Save the Mary River Coordinating Group

Re: Submission on the SEQ Water Strategy Draft

The purpose of this submission is to provide feedback on the Draft SEQ Water Strategy dated March 2008.

Figure E Projected infrastructure program: Climate resilient and surface supplies (medium series population growth and no allowance for climate change)

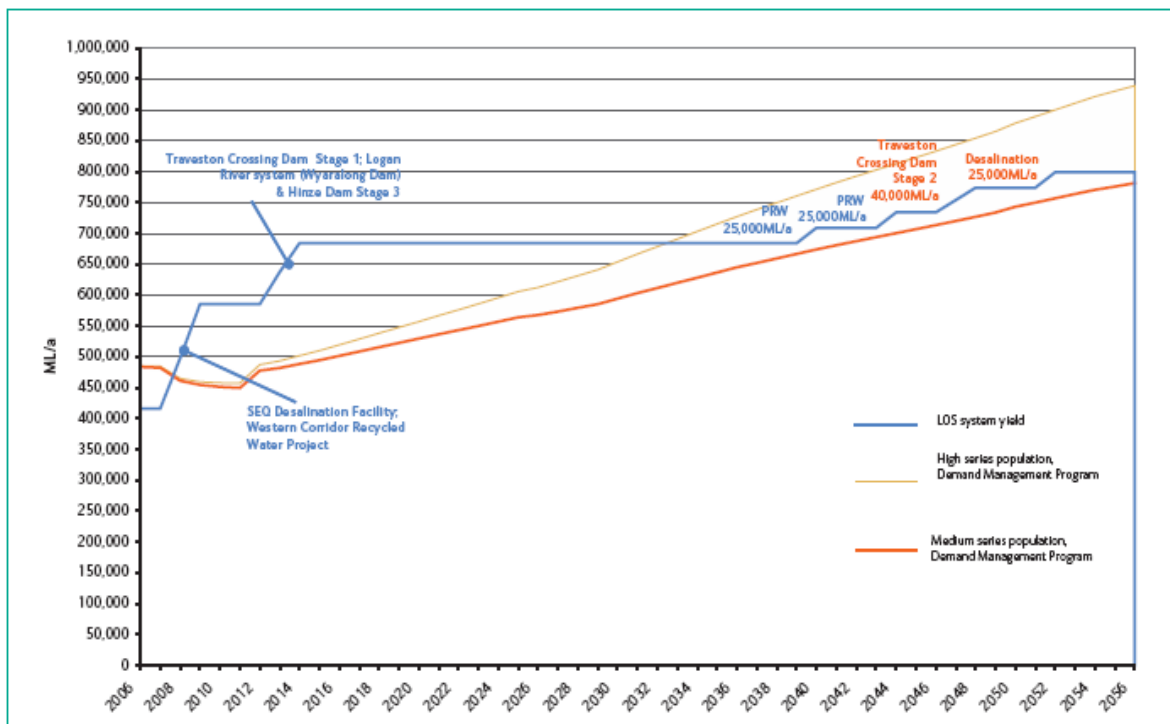
Looking in detail at the supply demand graph (Figure E on p 21 -shown below) shows that when the Western Corridor recycling scheme and the Gold Coast Desalination facility come on line, yield from the proposed Traveston Crossing Dam would provide a surplus for the next 20-25 years. Why are alternatives to such a financially, socially and environmentally costly projects as Traveston Crossing Dam and Wyaralong not being investigated in the draft strategy? **What is this surplus water going to be used for?**

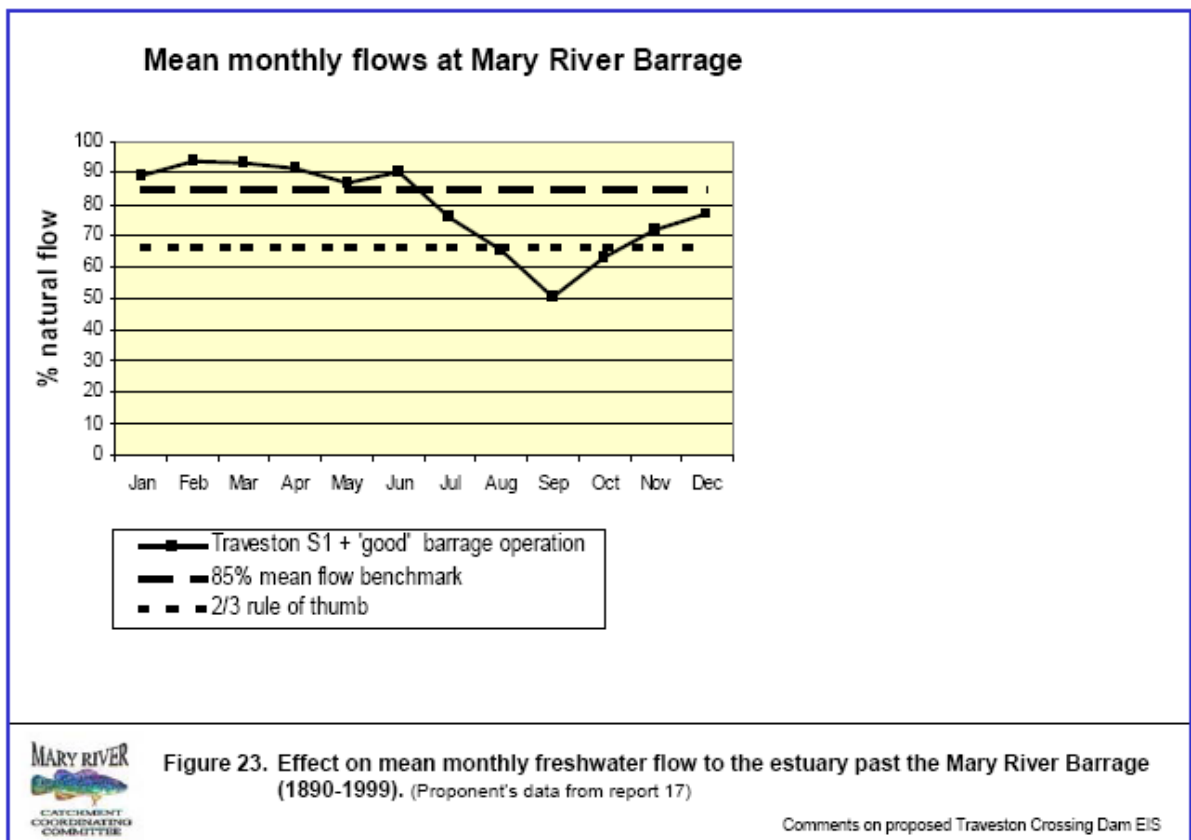
The SEQ water strategy draft uses only a 10% reduction in surface water storage yields in response to climate change (p16). However recent predicted drop of 10% in rainfall for SEQ is more likely to result in a 30% decline in stream flow in the Mary over the 50 year life of the strategy (MRCCC 2008).

Already, measured stream flow at the Traveston Crossing dam site over the last decade (which includes major flood events) is less than 60% of the long-term averages used to develop the Mary Basin Water Resource Plan (STMRCG 2008).

Figure 24. Illustration that flows do not comply with median flow objectives in the full allocation scenario, and that TCD stage 1 increases the level of non-compliance. (Proponent's data, EIS tables 6.37 & 6.38)

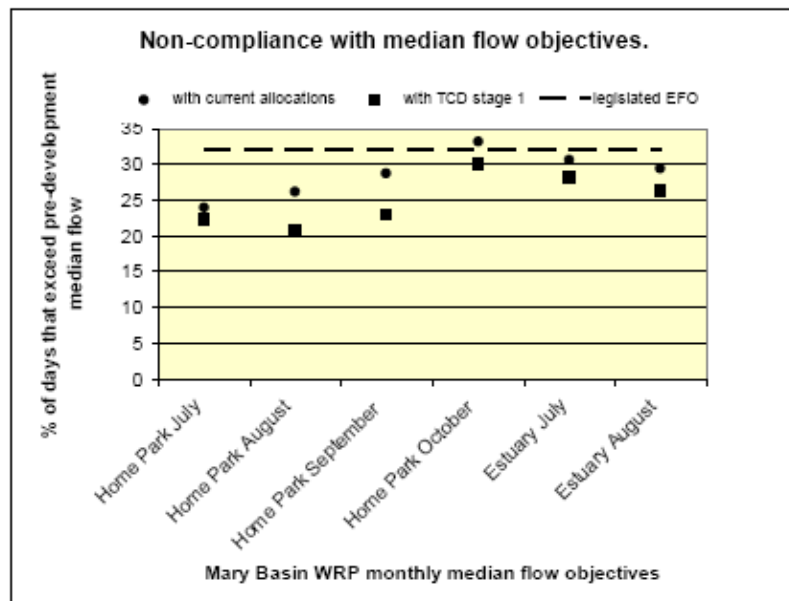
The proponent's data shows that, even as far downstream from the damsite as the entrance to the estuary at the barrage, the proposal is predicted to reduce September flows to about half of their natural state and generally significantly reduce flows during the JASON months.

This figure illustrates the extent to which median ('typical') flows in the lower river would not comply with the environmental flow objectives in the Mary Basin Water Resource Plan if all existing water allocations were fully utilized. It also shows how much further outside compliance the flows would be if Stage 1 of the Traveston Crossing Dam came into operation. It is difficult to see how this intent to make matters worse than they currently are could be interpreted as 'minimizing' the extent to which flows don't meet the objectives, as required under the plan. It is also hard to see how current allocations can be supported and the operation of the dam optimized to bring these figures into compliance without reducing the stated yield of the dam by making specific environmental flow releases.
